593 & 601-603 Laurier Avenue West

UDRP REPORT
Official Plan and Zoning By-law Amendment Applications
June 15, 2025

URBAN DESIGN BRIEF

Response to UDRP Comments

Current Massing

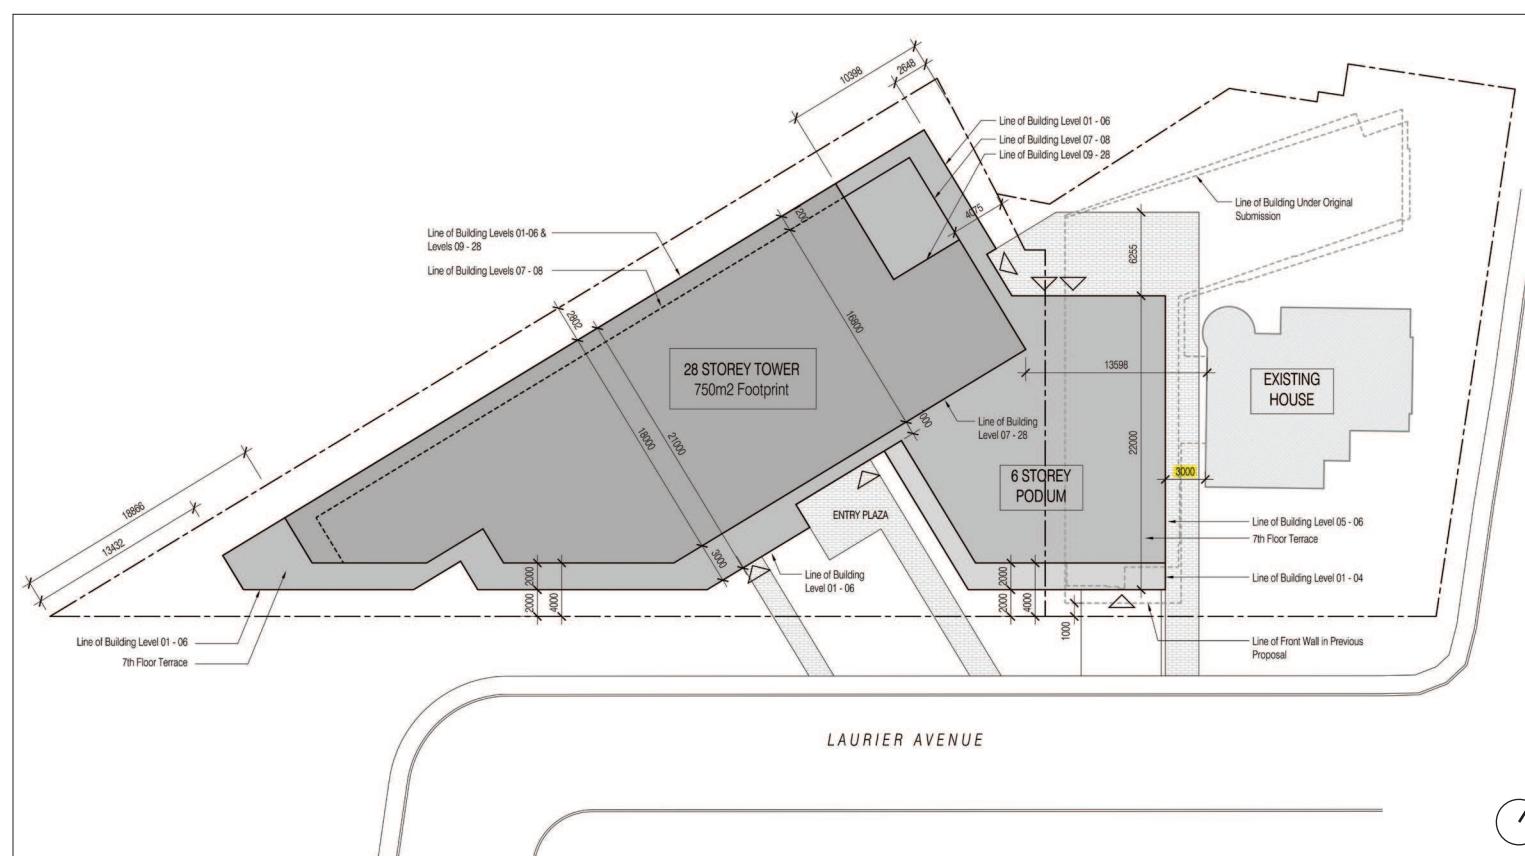
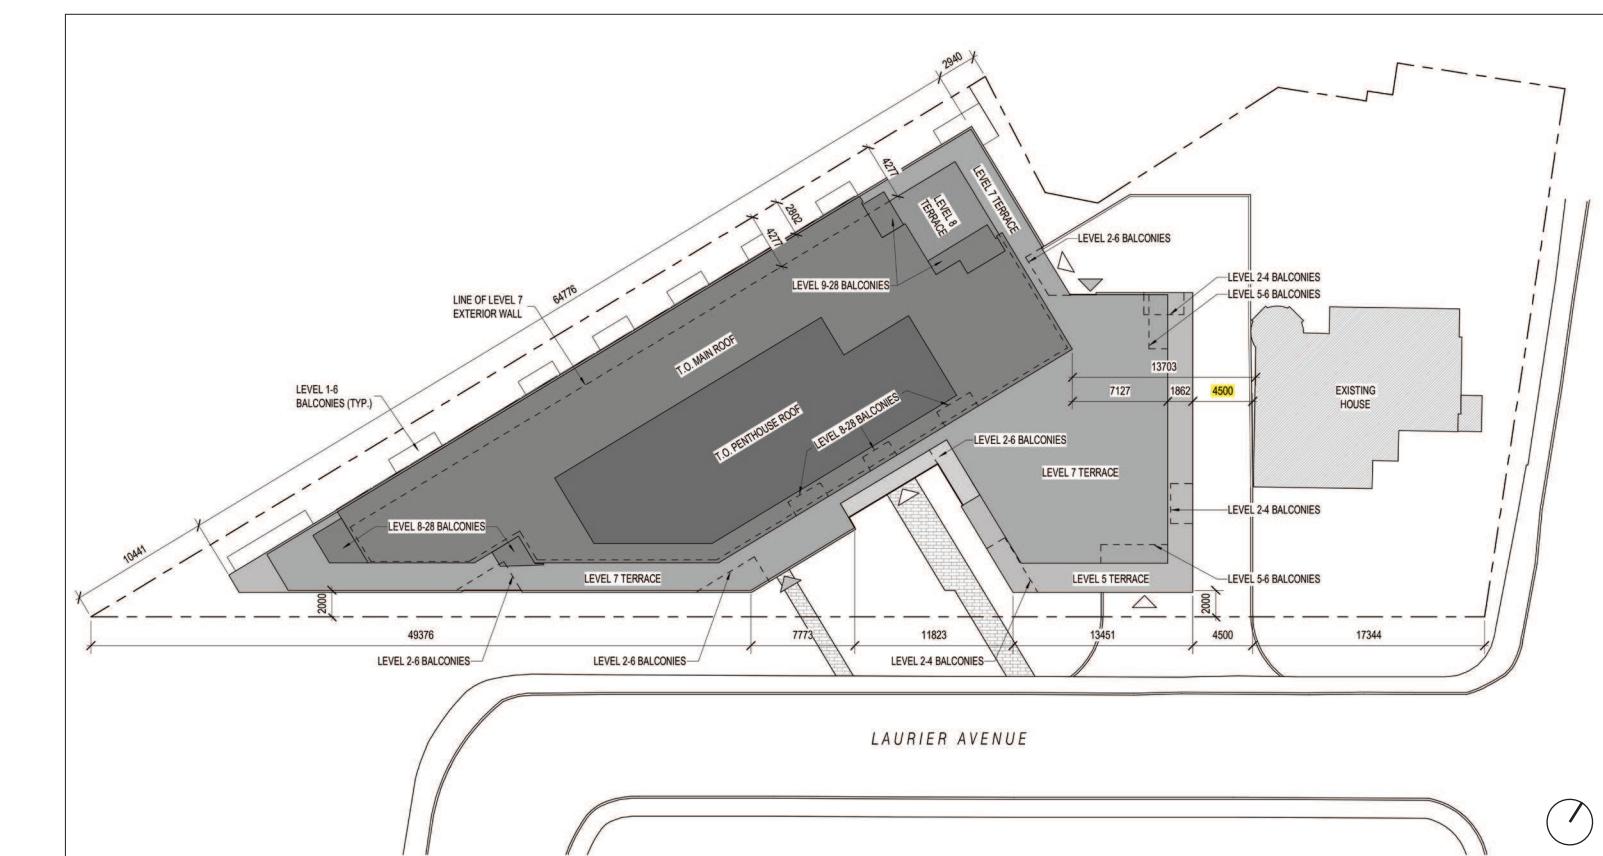
The podium may be high for the neighbourhood context and especially the relationship to the heritage house on the property. We recommend providing additional design/massing details so we may better understand the approach being taken.

We have increased the separation from the heritage house to 4.5m from 3m and introduced a stepback and material change above level 4 to better integrate the podium with the neighborhood context. These adjustments help to mitigate the podium height and ensure a more harmonious relationship with the heritage house.

The initial massing concept positioned the proposed development 3 meters from the existing Heritage House for the first six storeys of the podium. This approach was primarily driven by the objective to maximize leasable space, providing ample room for residential units while maintaining vehicular access to essential building services at the rear. This configuration, however, raised concerns about the proximity to the Heritage House and its impact on both the historical context and practical access, and required further consideration to improve spatial dynamics and circulation.

In response to these concerns, the current design iteration has been refined to enhance both spatial and aesthetic relationships. The podium has been shifted an additional 1.5 meters away from the Heritage House, resulting in a total separation of 4.5 meters. Furthermore, levels five and six of the podium are now recessed an additional 1.8 meters, creating a more gradual transition to the tower levels above. The first four levels of the podium, which align with the height of the Heritage House, will feature red-tone brick complimenting the red brick of the existing structure. This material choice reinforces the architectural dialogue between the new and existing building.
